Renown Apparels Ltd. (11800)

Identified Priority 1 Concerns

1st Priority 1 Concern

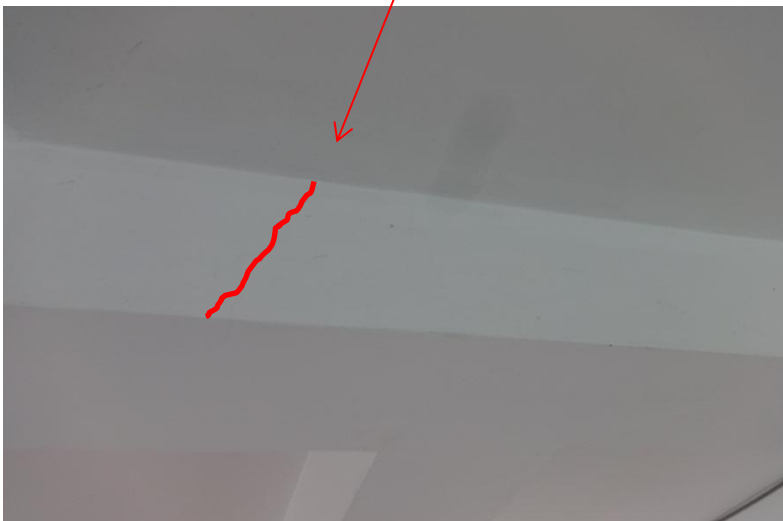
High stresses to internal columns, factor of safety between 1.25 & 1.50 based on current loading.

If all floors are loaded to 2kPa (40psf) the columns would still be overstressed.

Item No.	Observation	Recommended Action Plan	Recommended Timeline
1	Priority 1 - High stresses to internal columns, factor of safety between 1.5 & 1.86 based on current loading.	Ensure that the slabs are not loaded above 2.0kPa (40psf).	Immediate - Now
2	Priority 1 - High stresses to internal columns, factor of safety between 1.5 & 1.86 based on current loading.	Carry out a Detailed Engineering Assessment on the columns, taking 100mm core samples where necessary to establish the strength.	6-weeks
3	Priority 1 - High stresses to internal columns, factor of safety between 1.5 & 1.86 based on current loading.	Carry out any recommendations highlighted in the Detailed Engineering Assessment.	6-months
4	Priority 2 - Shear cracking observed at beam - beam connections.	Carry out a Detailed Engineering Assessment on the beams, removing plaster, to establish the extent of the cracks in the beams and what load they can safely support.	6-weeks

2nd Priority 2 Concern

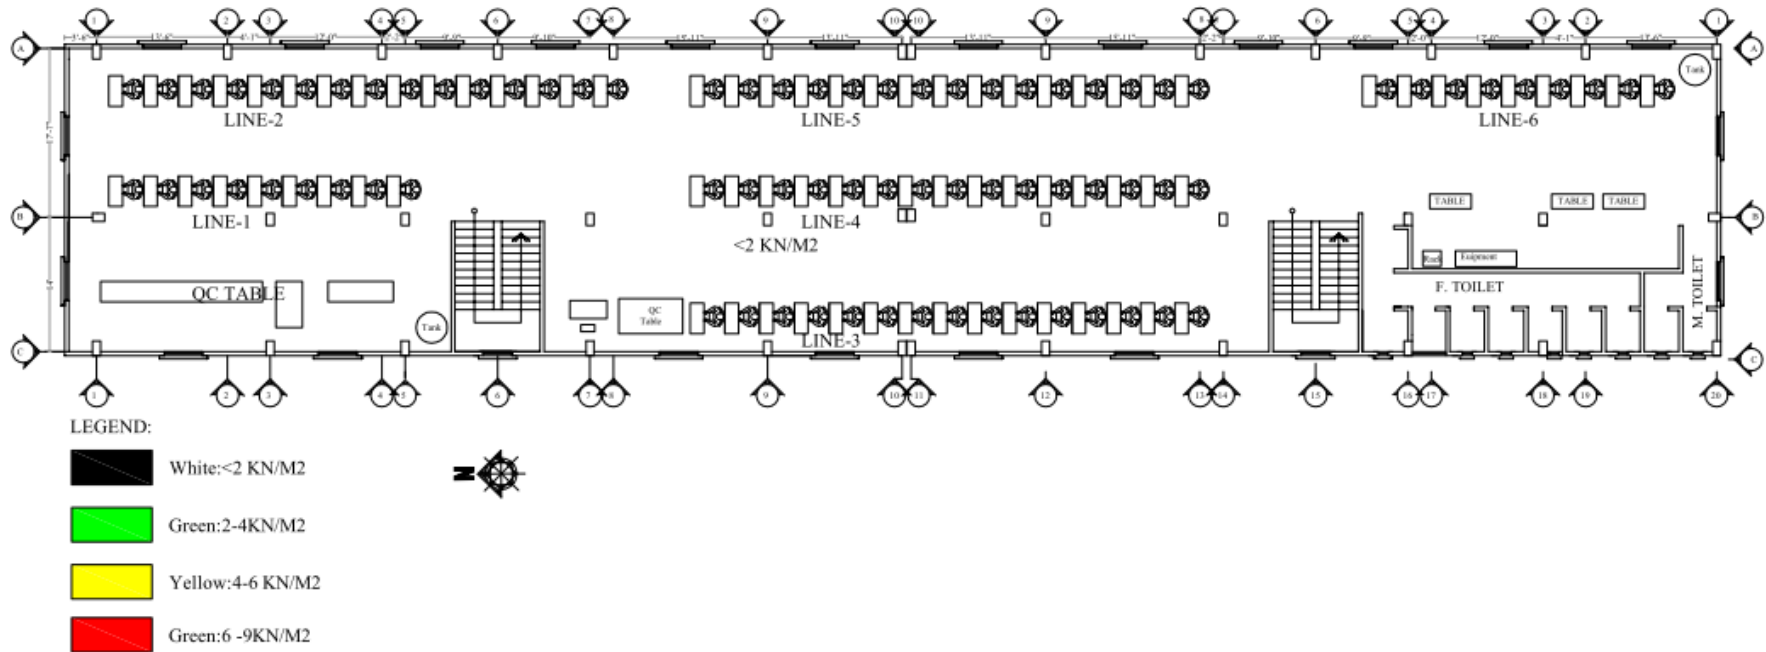
Plinths have been constructed on the slab around wash room areas & cracks were observed in the beams below.

150mm – 250mm
plinths constructed
on slab around the
washing area

The plinth will weigh up to
5.0kPa.
 $(250/1000) \times 20 = 5.0\text{kPa}$

5	Priority 2 - Shear cracking observed at beam - beam connections.	Carry out actions from the Detailed Engineering Assessment.	6-months
6	Priority 2 - Plinths have been constructed on the slab around wash room areas & cracks were observed in the beams below.	Carry out a Detailed Engineering Assessment to determine if the slab is adequate to support the higher dead load of the plinth.	6-weeks
7	Priority 2 - Plinths have been constructed on the slab around wash room areas & cracks were observed in the beams below.	Carry out actions highlighted in the Detailed Engineering Assessment, removing or lowering the heights of the plinths as required.	6-months

TITLE:-
2nd & 3rd Floor Load Plan
LOCATION:-
BHATIARY LINK ROAD, BARDHEGHIR PAR,
HATHAZARI, CHITTAGONG

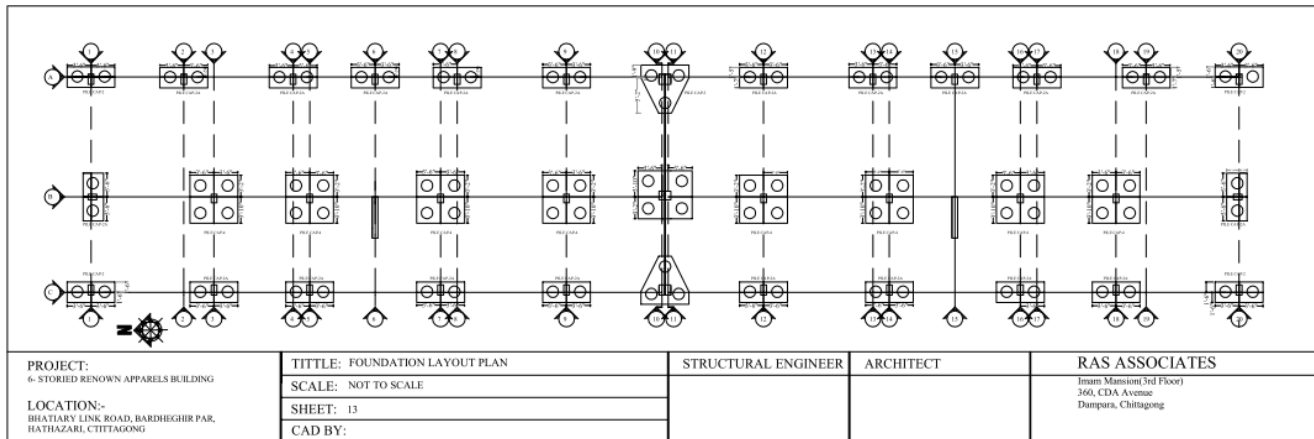
Loading plans exist for the structure, but are not displayed.
